# Work Order ID 84915

Item Name: Skidtube RH

# **DART SERVICE INSTRUCTION**

**TO AMEND INSTALLATION INSTRUCTIONS IIN-D209-669 REV. B**

INSTALL TOW RING ASSEMBLY AS SHOWN BELOW (REFER TO SECTION F-F OF IIN-D209-669 REV. B.

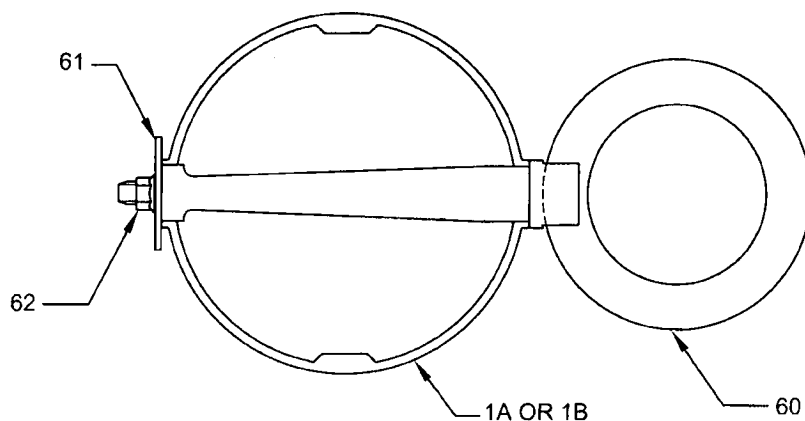
**IS:**

**WAS:**

- a) REPLACE THE D2968-041 TOW RING WITH THE D3407-041 TOW RING ASSEMBLY.
- b) REPLACE THE D2736-1 AND D2736-3 GHW LUGS WITH THE D3405-041 AND D3405-043 LUG ASSEMBLIES.
- c) AMEND THE PARTS LIST IN SECTION 5.0 OF INSTALLATION INSTRUCTIONS IIN-D209-669 REV. B AS SHOWN ON PAGE 2 OF THIS DSI.
